From: Amy Ruth <aruth@diversifiedfsi.com>
Sent: Friday, October 11, 2013 9:45 AM
To: Bratcher, Mike, EMNRD
Cc: SJWalters@BassPet.Com; Michael Patterson; Stephen McGhee
Subject: RE: Concern about BOPCO PLU #139

Site Diagram with Field Sample Data

BOPCO PLU #139
2RP-901
 UL/J, Sec 24, T24S R30E
 Eddy County, NM
 Drafted By: A.C. Ruth, 10/9/13
 Not to Scale

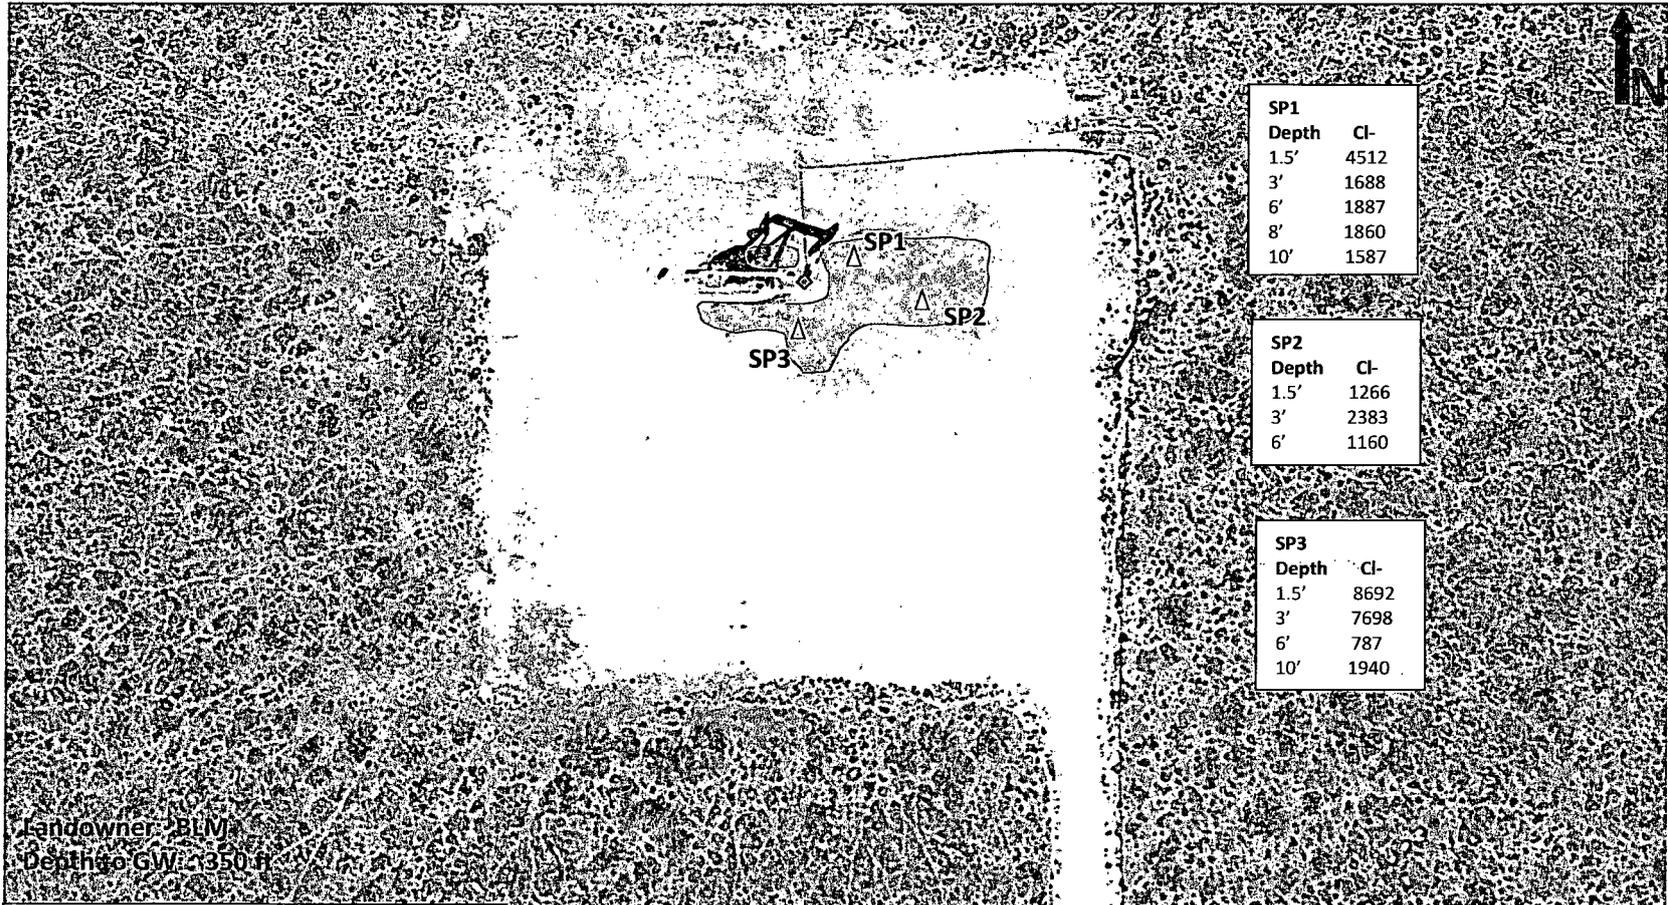
I just left you a voicemail because I've got a situation on the BOPCO PLU #139 and need to ask for your advice. At this site, I delineated the leak in the field using Standard Method 4500 cl- B, as always (field data is on the attached plat). The site was excavated to 3' bgs, a 20 mil liner was installed, one of the 3 sample points (SP3) was installed with a PVC pipe for possible drilling, and the excavation was backfilled. I realized today that I had inadvertently disposed of the samples for this site without submitting them to the lab.

I thought it might be acceptable to auger in at an angle under the liner, say around the perimeter in several places to grab samples as deep as we can reach so as not to compromise the liner. We had encountered auger refusal at approximately 6' bgs at this site during our previous delineation and had to use a backhoe to grab 8' and 10' samples. That's as deep as we were able to get with the backhoe due to the compacted caliche at that depth.

Thank you so much for your assistance with this site. Per our discussion this morning, BOPCO will drill the site at SP3 to delineate that point. Due to the problem with the unavailable lab data and the difficulty of retrieving new samples from under the liner, our field data along with drilling lab data at SP3 will be sufficient in this case. Again, thanks and talk to you soon.

10/11 Called Amy - samples obtained will be ok - they will go back in w/ris to delineate
